**RE: BEK Distribution Facility
601 Gallatin Place NW
Grading and Drainage Plan & Drainage Report
Engineer's Stamp Date: 09/06/19
Hydrology File: J10D002G1**

Based upon the information provided in your resubmittal received 09/06/2019, the Grading & Drainage Plan and Drainage Report are approved for Building Permit, Grading Permit, and for action by the DRB on Site Plan for Building Permit.

RE: **BEK DISTRIBUTION FACILITY – 601 GALLATIN PL. NW
D&D PLAN AND DRAINAGE REPORT ENGINEERS
STAMP DATE 07/19/2019, HYDROLOGY FILE: FJ10D002G1**

Revision No.	△
△	
△	
△	
Job No.	2018014
CD/CHK'D BY	PJM / VC
Date	9-26-19
Sheet Title	DEVELOPED DRAINAGE BASINS
Sheet No.	1
CIVIL

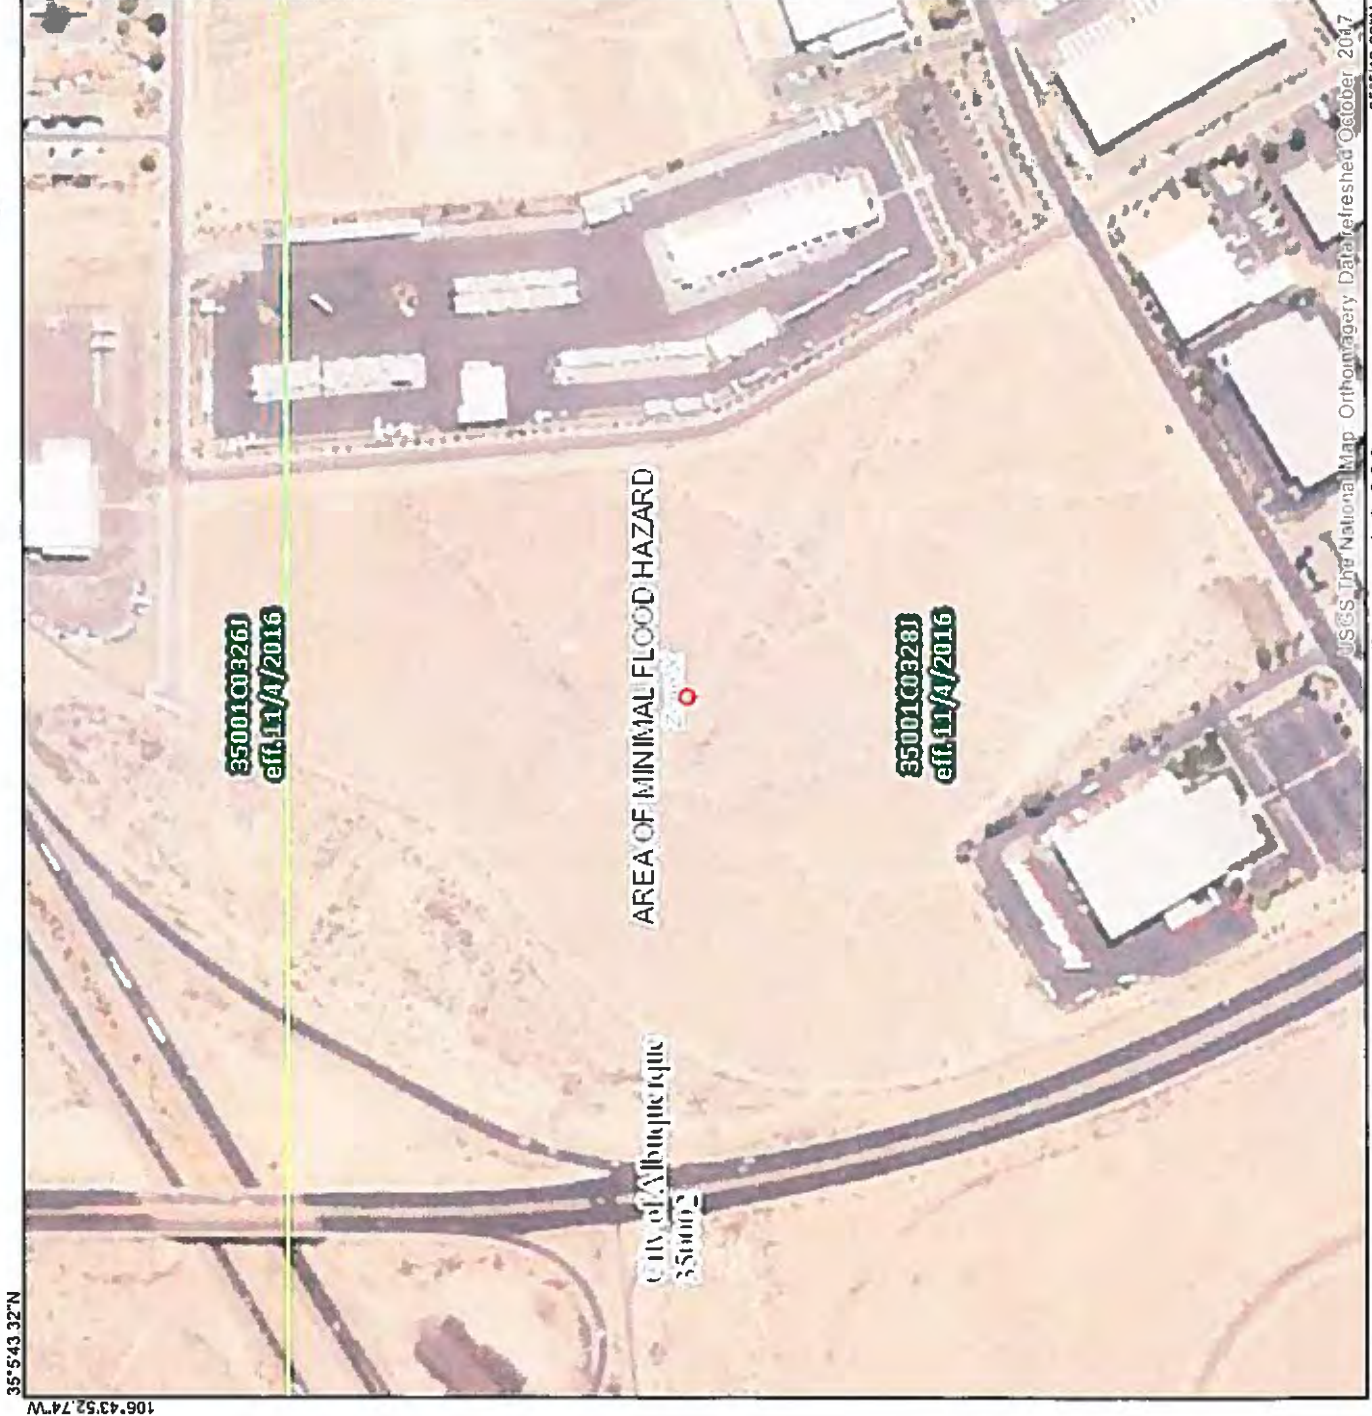
15. Please revise the Drainage Basin map to include a graphic scale, north arrow, flow arrows indicating the discharge point of each basin and roof drainage patterns. The paper copy must be scalable.

Response: The drainage basin map (Sheet 1) was revised with a graphic scale, north arrow and flow arrows and is to scale.

NORTH POND:

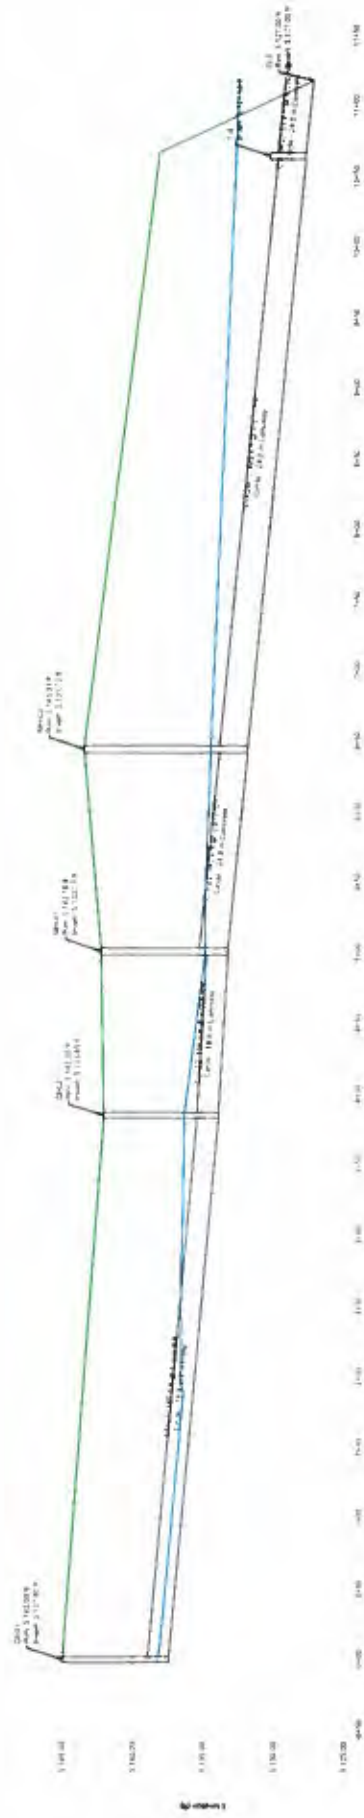
14. Please revise the pond volume calculations to use the Conic approximation method (the volume of a frustum) = $h/3 \times [b1 + b2 + \text{sqrt}(b1 \times b2)]$ where h is the height between the two areas and b1 and b2 are the areas of the contours. The equations presented in the report do not make any sense, but the volumes seem to have been calculated by the average end area method. The method used for volume calculations needs to be better documented in the report. Also please provide the excel file.

Response: The pond volumes were recalculated using the conic approximation method as requested. The calculations are provided in the report. The provided ponding capacities are greater than the required 10-day volumes.

Revision No. _____
 Job No. _____
 2018014
 CAD/CHK'D By: _____
 pm / vc
 Date _____
 8-16-19
 Sheet Title _____
 OVERALL GRADING PLAN
 Sheet No. _____
 C201
 CIVIL

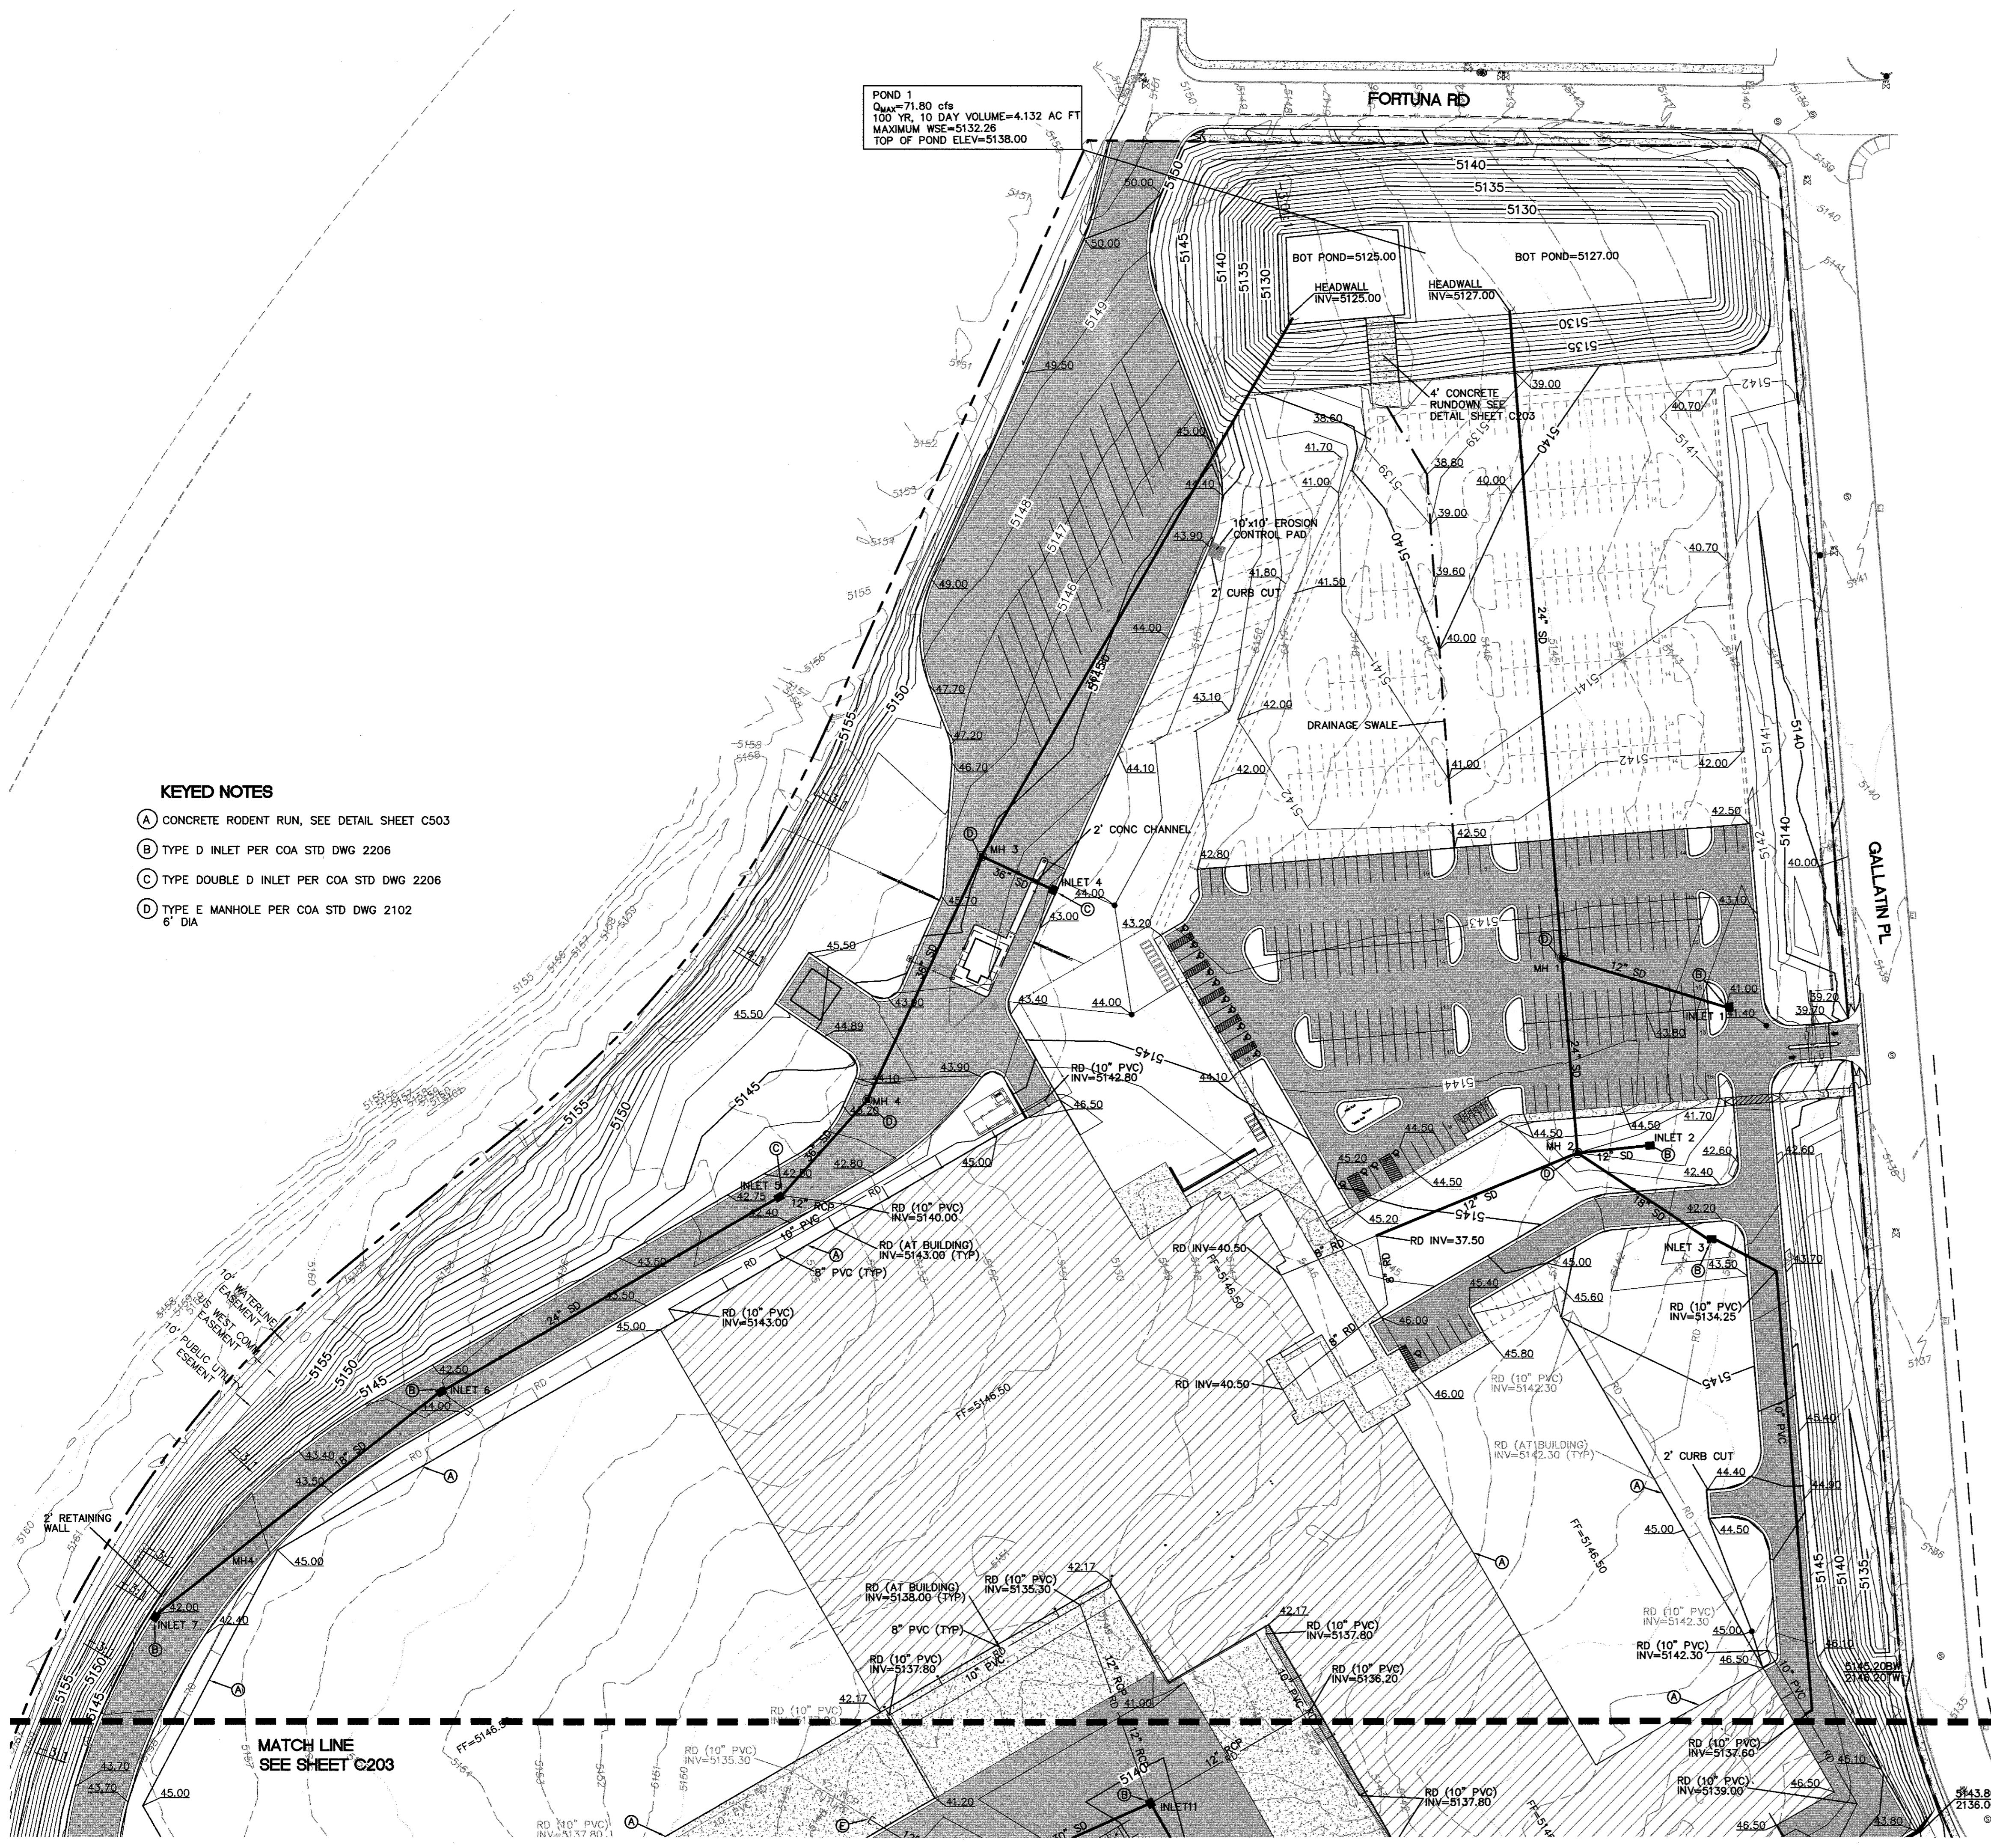
6. Please label the contours in the north east corner of the parking lot and verify that the spot elevations agree with the contours. If they are not 5141 and 5142 then please revise the grading to decisively contain the parking lot drainage and convey it into the north pond.

7. The contours indicate erratic slopes varying from 1% to 10% with abrupt grade changes in the northwesterly 250' of the staging/parking lot. Please revise the grading.

12. Please add the Book and Page (B 2019C P 0040) of the plat to note 1 on sheet C201.
Response: The book and page number of the plat was added to Note 1 on Sheet C201.

Response: The noted contours (5141 & 5142) are now labeled and the parking lot drainage is conveyed into the north retention pond on Sheets C201 & C202.

Response: The contours were corrected to reflect proposed, non-erratic slopes in the noted staging/parking lot on Sheets C201 & C202.

Revision No.
 Job No.
 2018014
 CAD/CHK'D By.
 pm / vc
 Date
 8-16-19
 Sheet Title
 GRADING AND DRAINAGE PLAN
 Sheet No.
 C202
 CIVIL

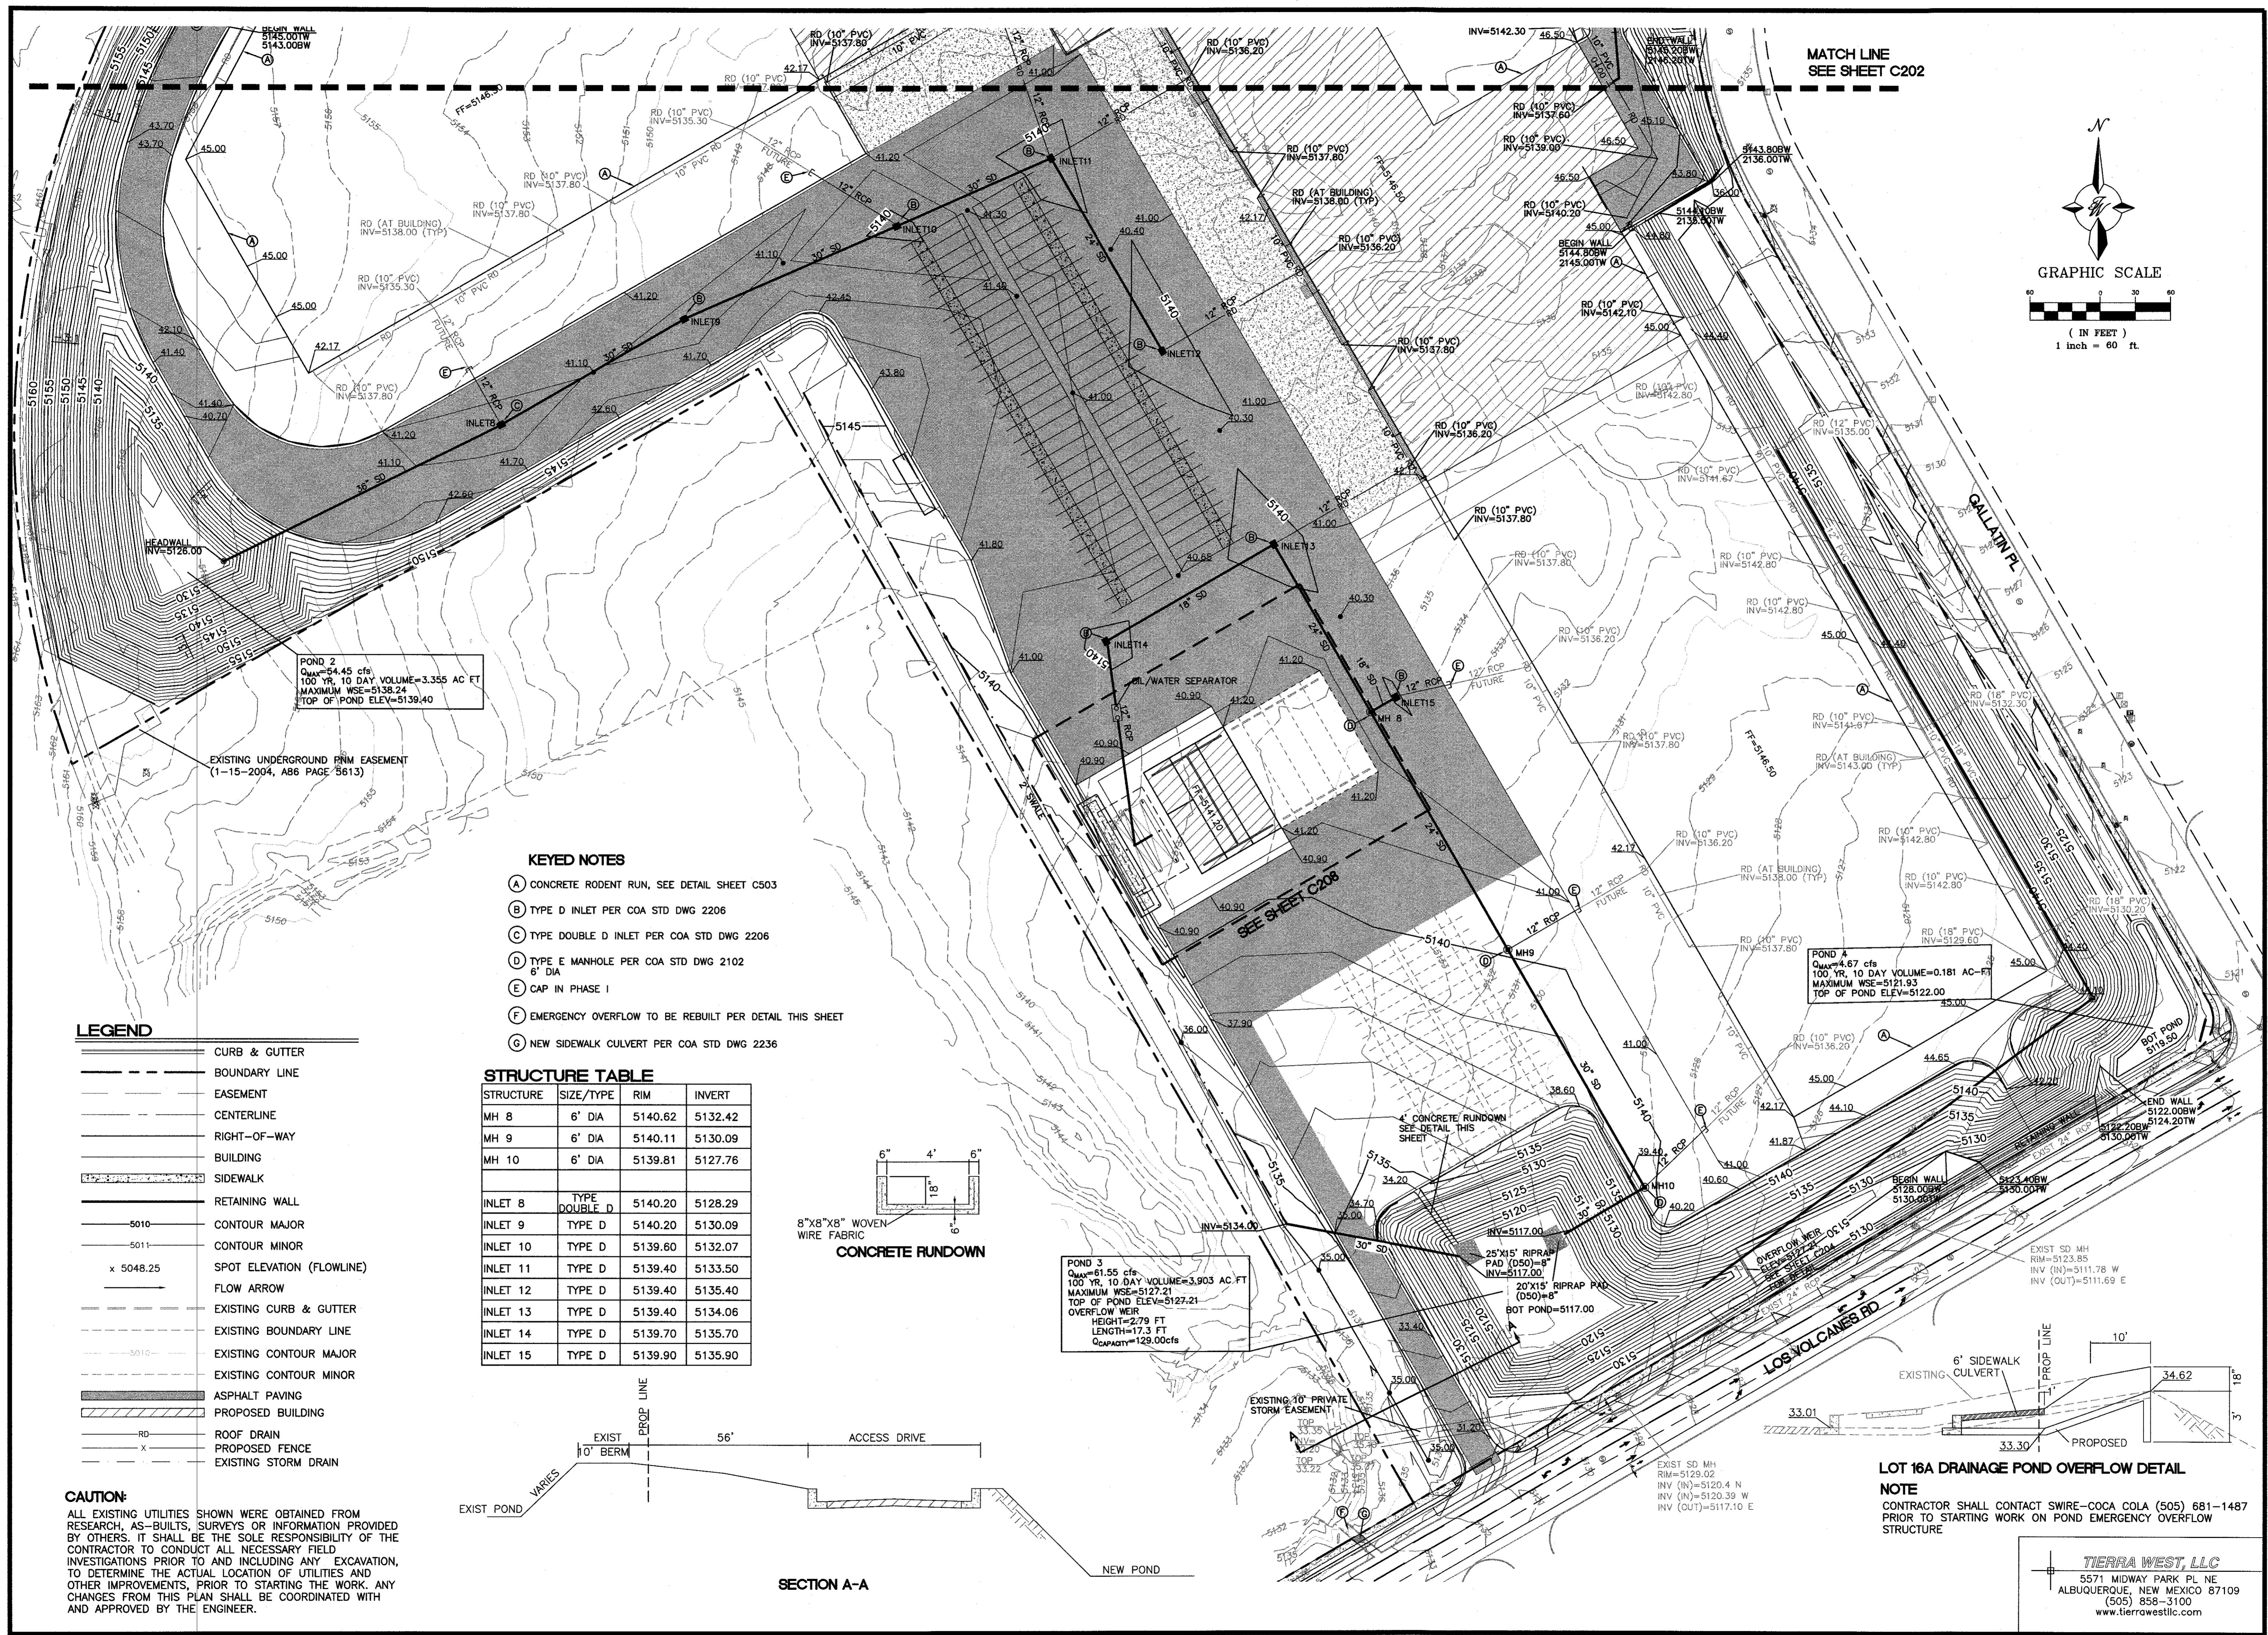
4. How will drainage get out of the sump in the C&G on the east side of the Staging area?

5. Surface drainage in the future staging area and the future parking lot next to the pond appears to enter the pond in two places but only one has a rundown. Lined conveyance systems should be added to the plan to convey drainage from the paving proposed with this building permit through the future paving area and into the pond. Please revise the G&D Plan adding lined swales and typical sections through the future north parking area and into the north pond.

Response: A 2ft curb cut and erosion pad were added to the proposed curb in the staging area will allow the drainage to continue east to the proposed swale and concrete rundown into the north retention pond, see Sheet C202.

Response: The G&D plan Sheets C201 & C202 were revised to reflect a single swale and concrete rundown into the north retention pond. All future parking and staging areas will be stabilized under interim conditions with gravel surfacing.
